Central Sewershed Package 7-Brackenridge High School
Solicitation Number: CO-00423
Job No.: 18-4543

ADDENDUM 02

May 28, 2021

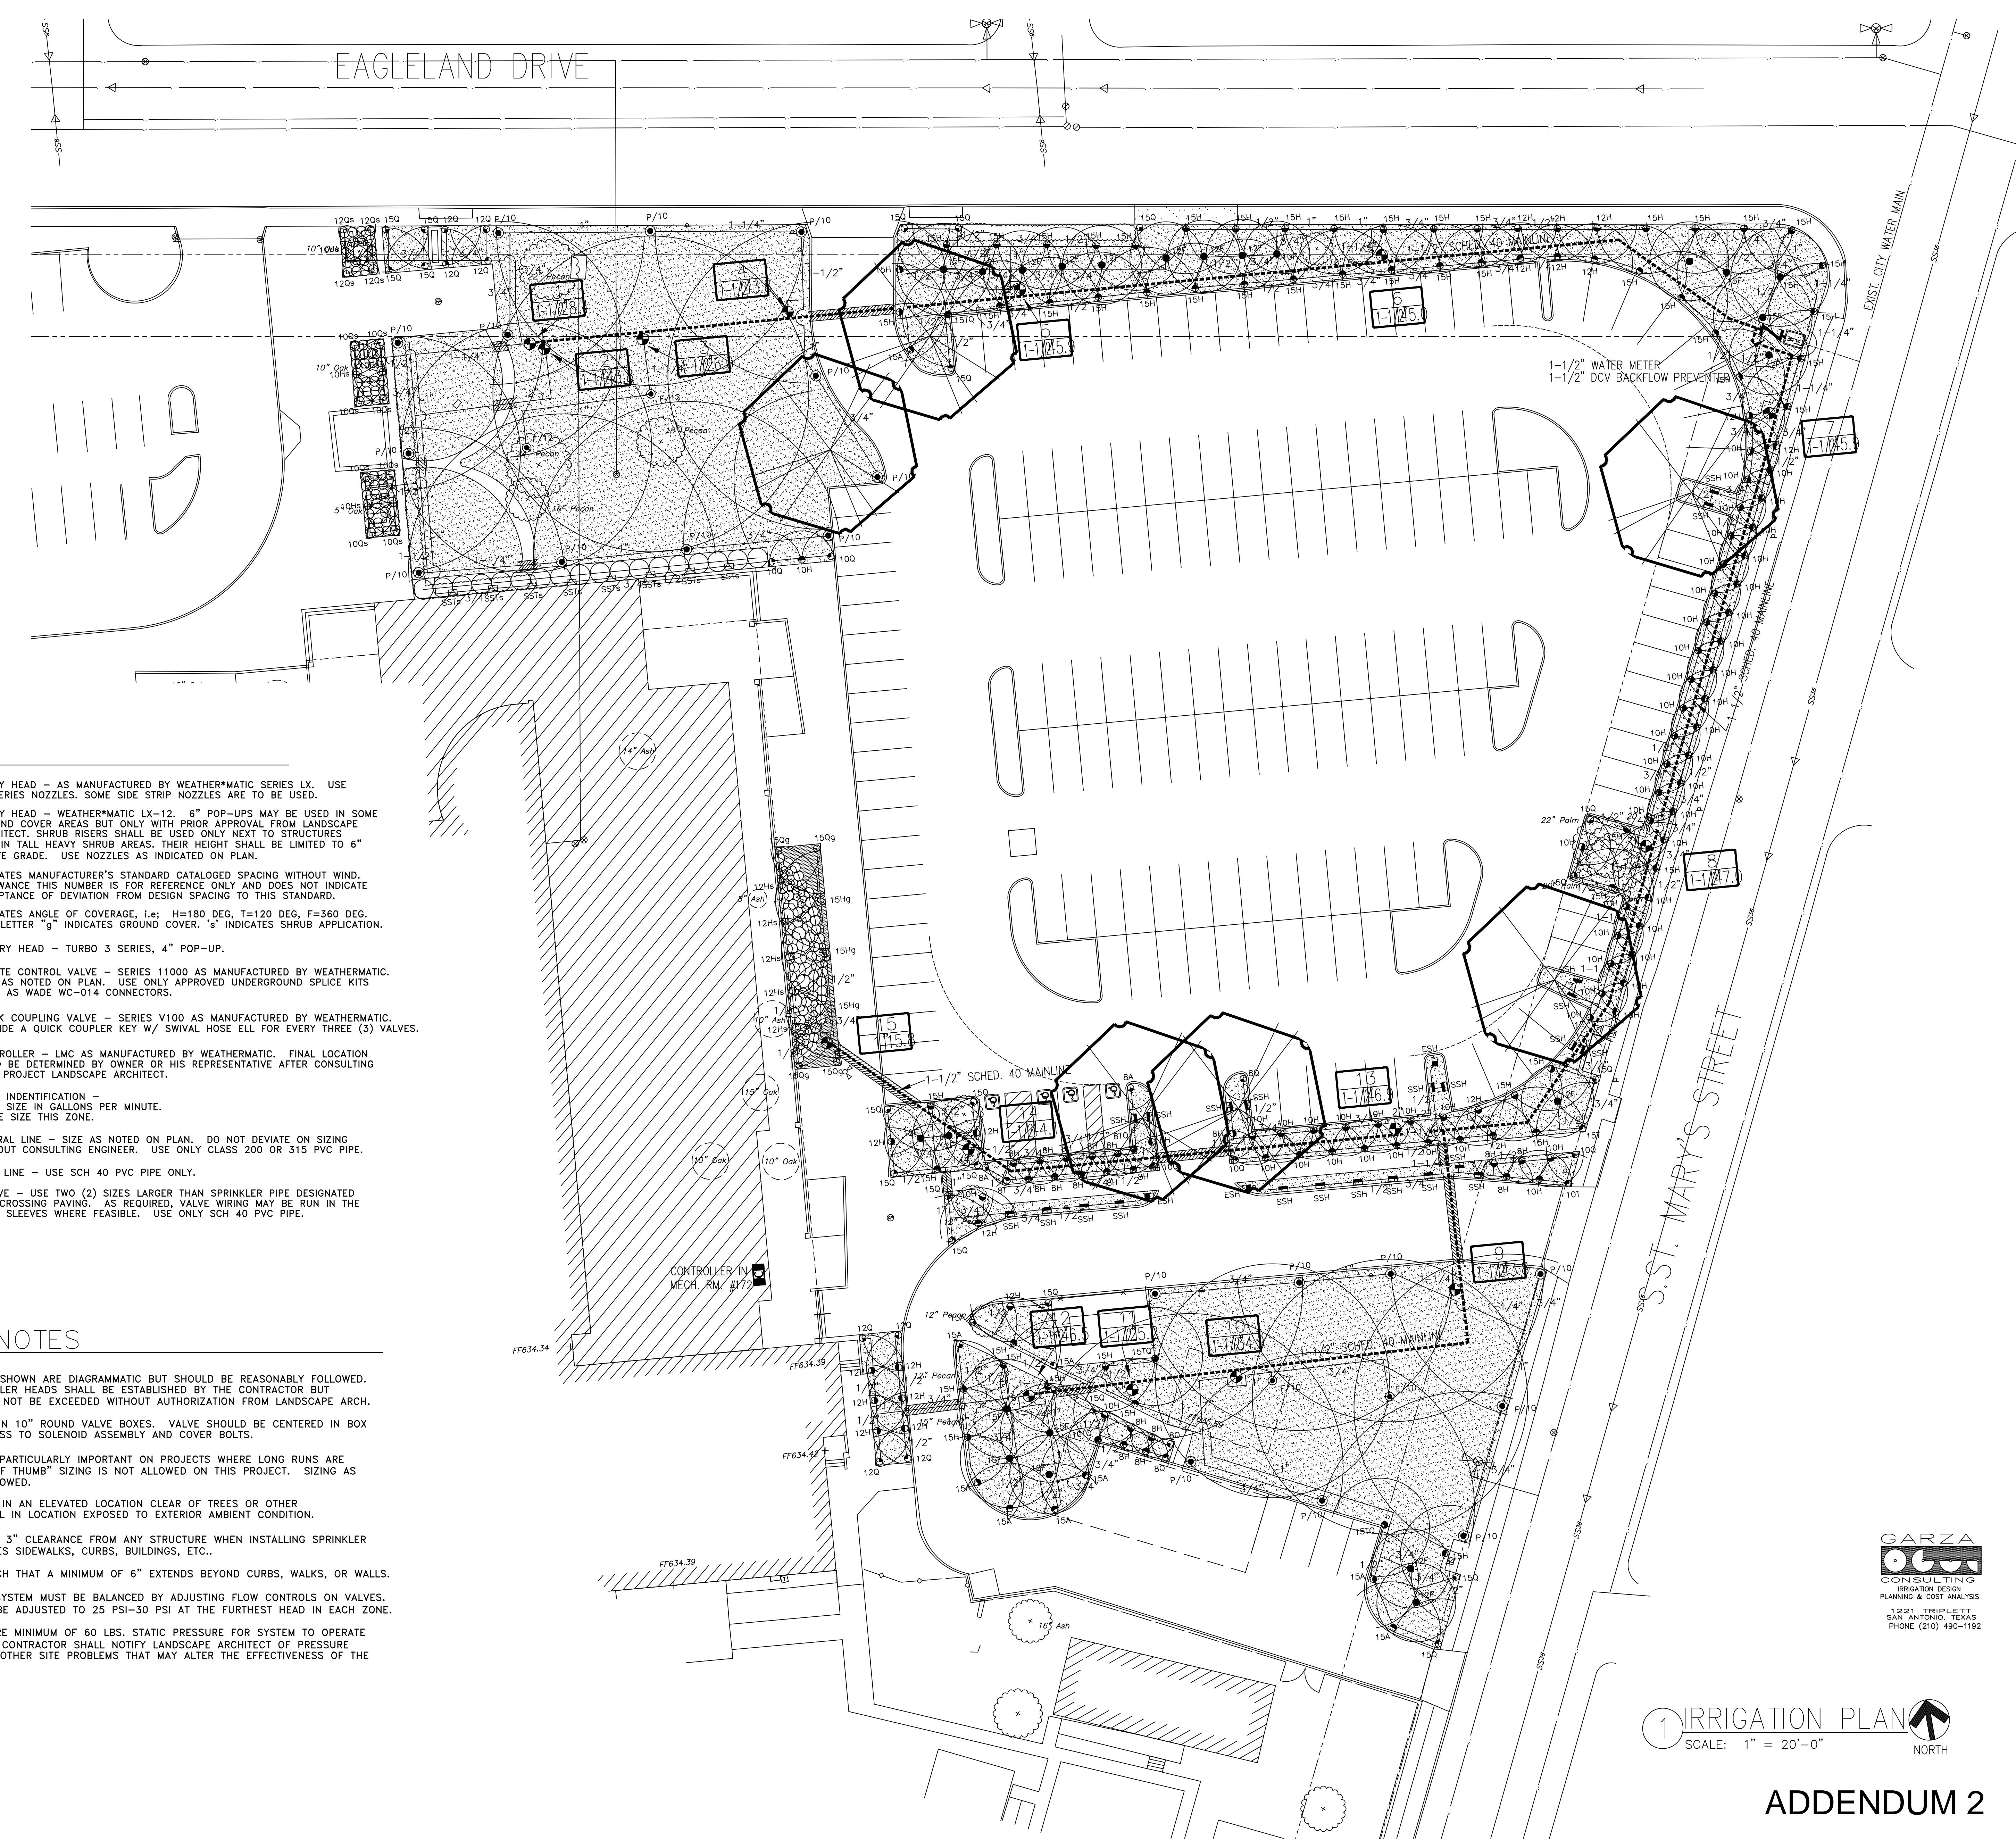
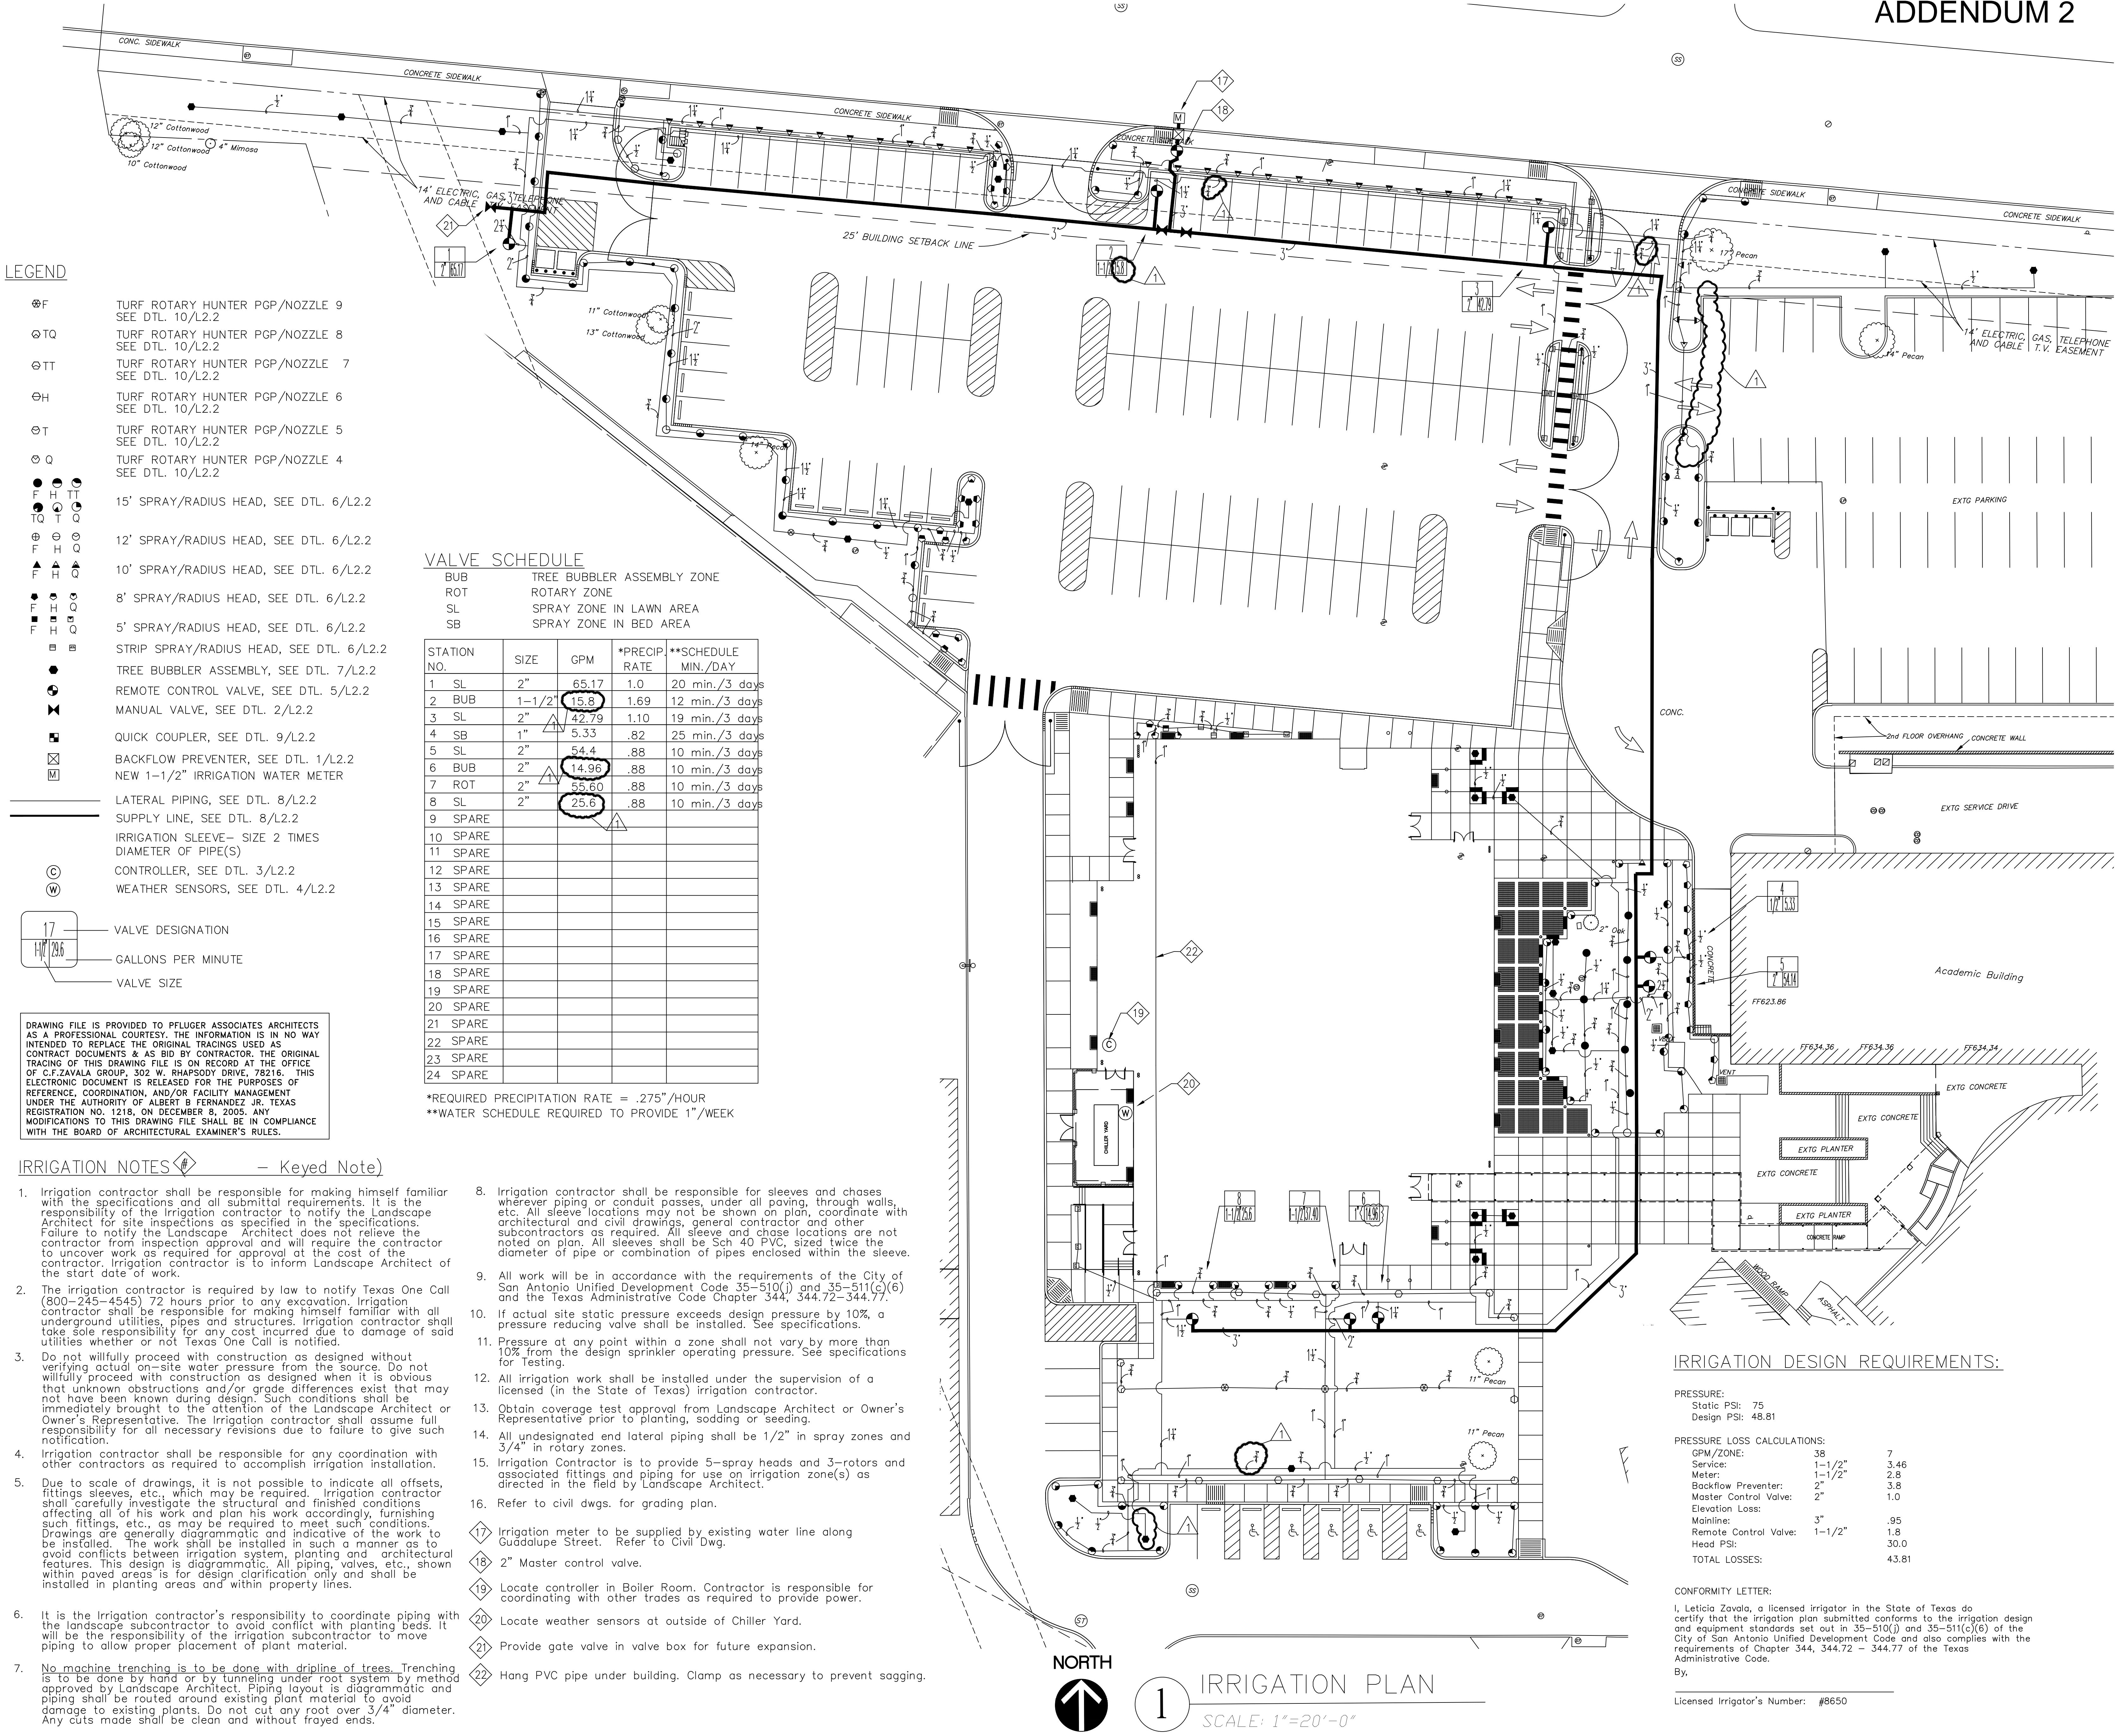
7. Is there any existing irrigation at school property and how will we get paid for relocating (please provide size and the location on the plans)? please add a bid item.

Answer: According to the BHS Phase 1 improvements, there are several irrigation pipelines that will be impacted by the construction of the new pipeline. The pipeline sizes include ½ -, ¾ -, 1-, 1 ¼ -, 1 ½ -inch, 2 ½ -, and 3 -inch. Refer to the Attachment 6 for the best available information regarding the location of these lines.

Bid item SS 1203 – Removal and Replacement of Existing Irrigation System has been added, refer to Attachment 1. Any removal and replacement of the existing irrigation system will be paid under bid item SS 1203. Contractor shall coordinate any irrigation shut down with BHS and SAISD. If the irrigation system is offline more than 24 hours, the contractor shall provide water trucks to water areas where irrigation system is offline. The delivery of water by trucks, materials, labor, and any other item needed for the removal and replacement of the irrigation system shall be paid under bid item SS 1203.
